EPC STORMWATER REVIEW COMMENTS
IN ORANGE BOXES WITH BLACK TEXT

**FINAL DRAINAGE REPORT
FOR
RETREAT AT TIMBERRIDGE
FILING NO. 3**

**CCES
RESPONSES**

PCD Project No. SF-22-041

BRIDGECOR TWO RADIUS ARCH
31'-11" MAX. SPAN X 11'-8" RISE
ARROYA CROSSING TIMBER RIDGE
COLORADO SPRINGS, CO

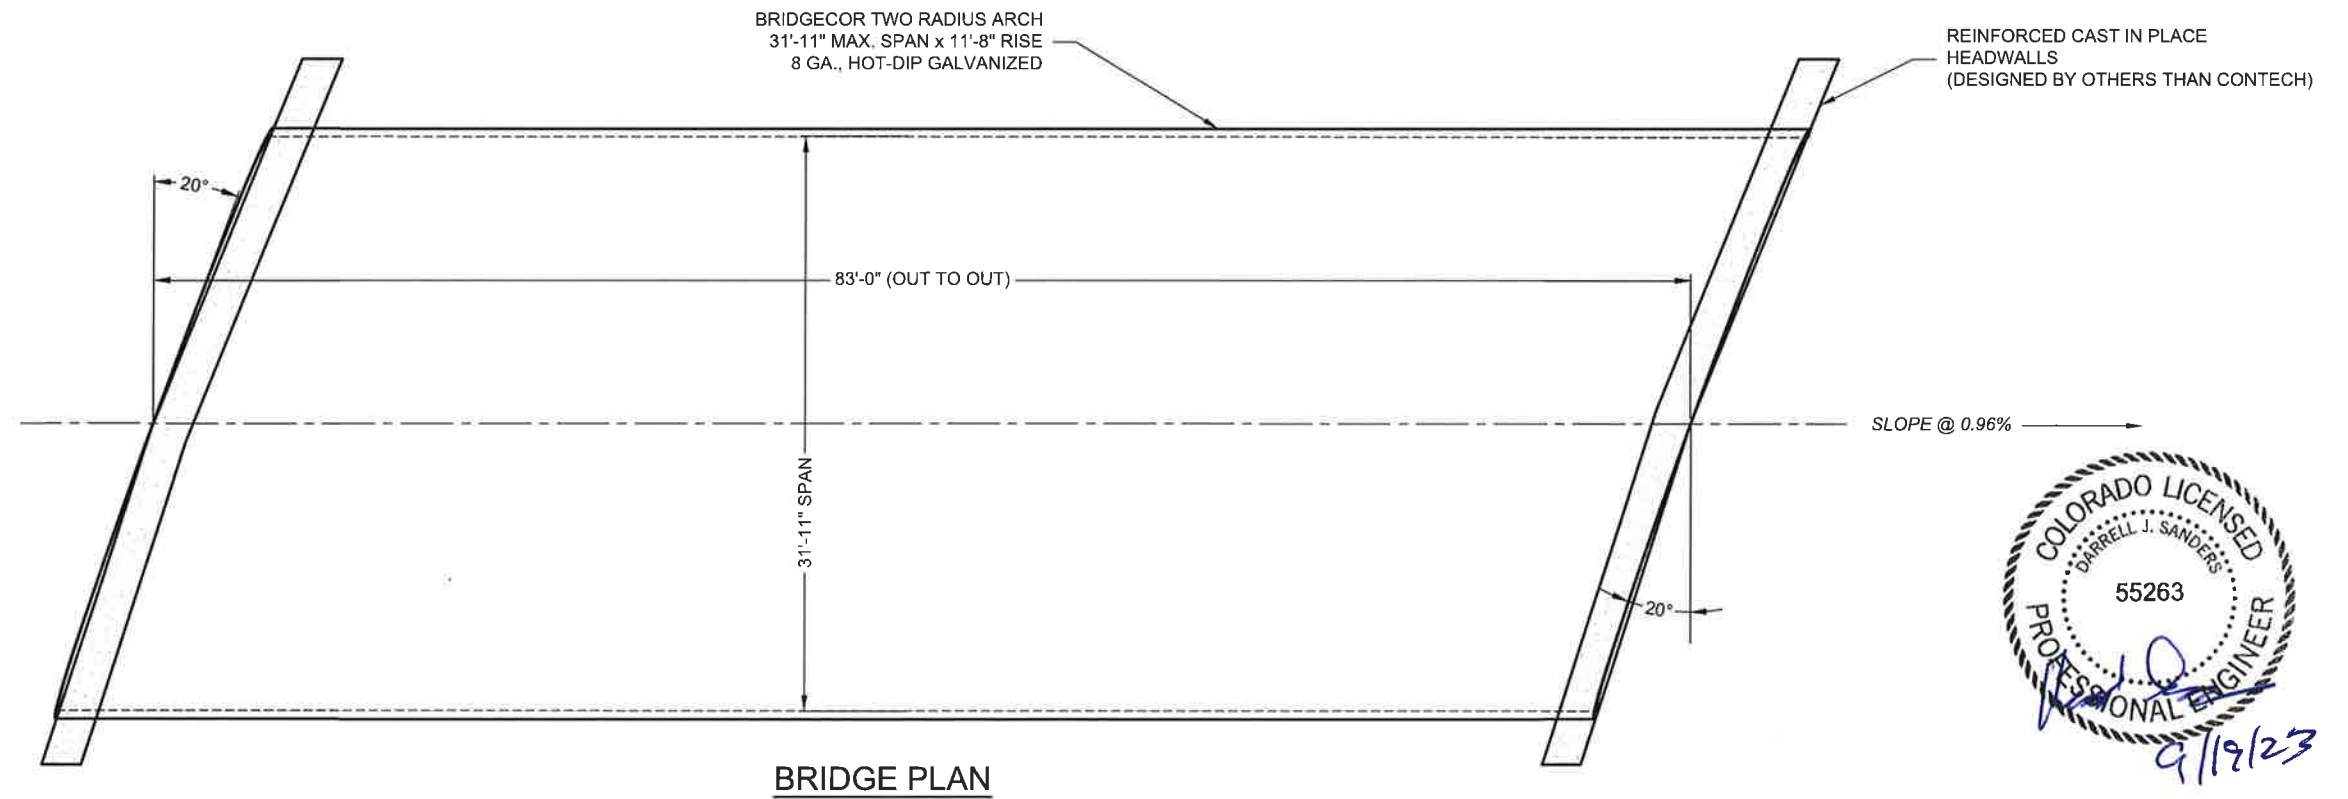
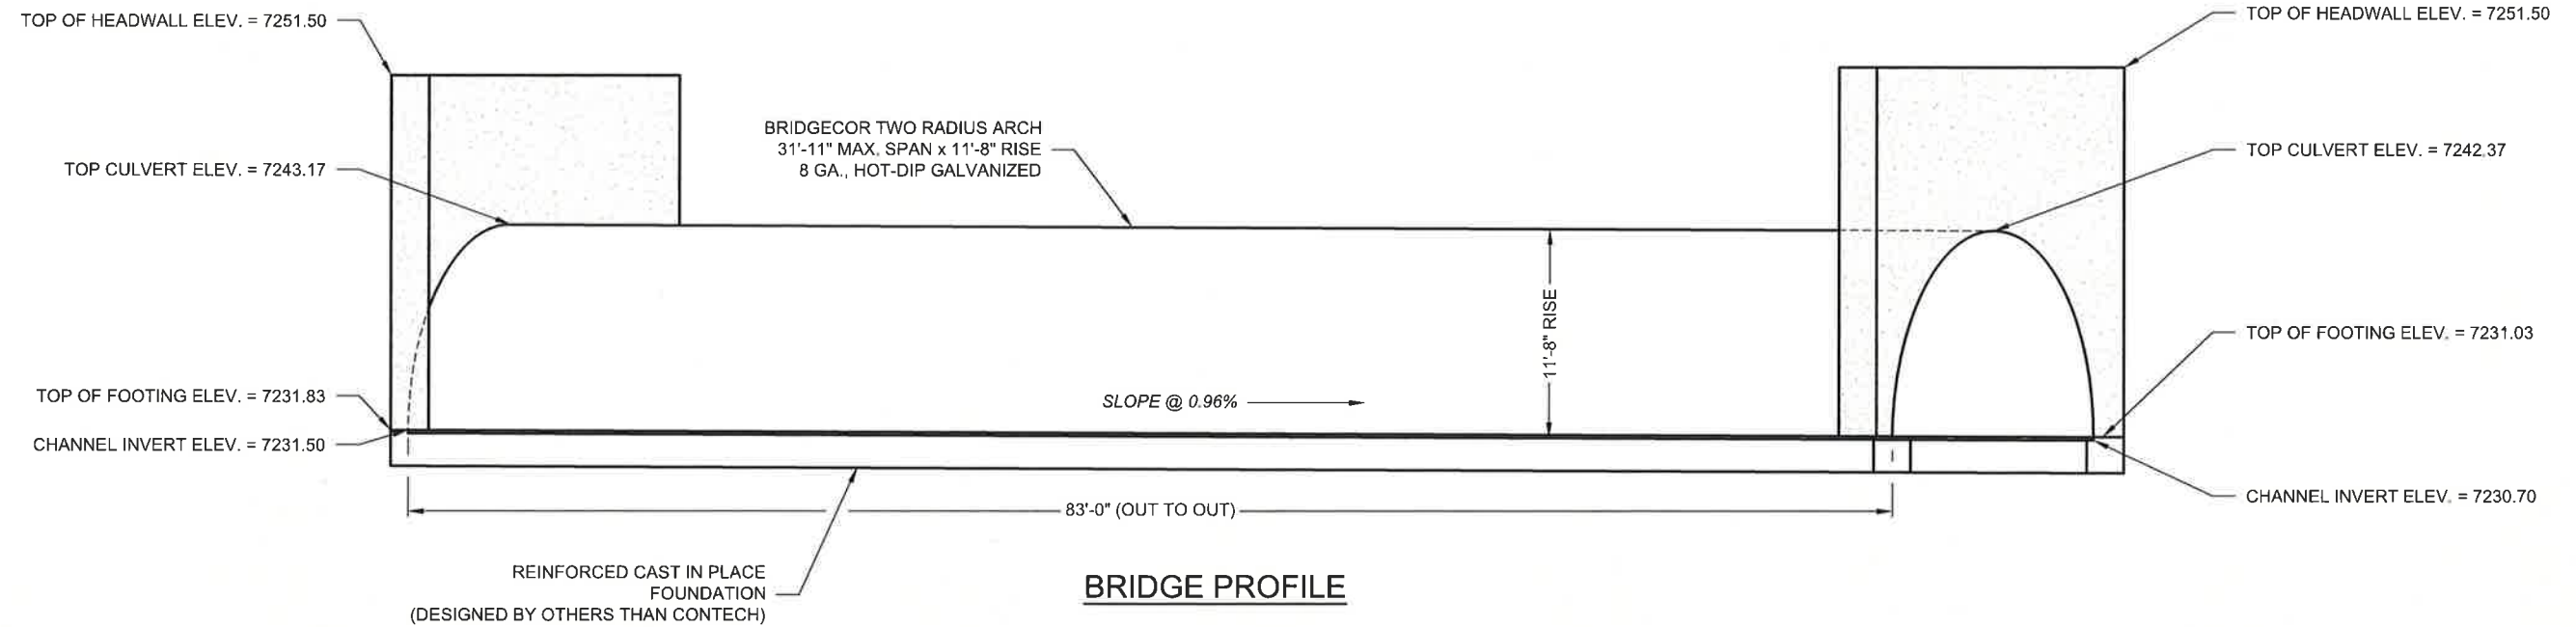
Unresolved:
Also provide a cross section showing water and gas line crossings.
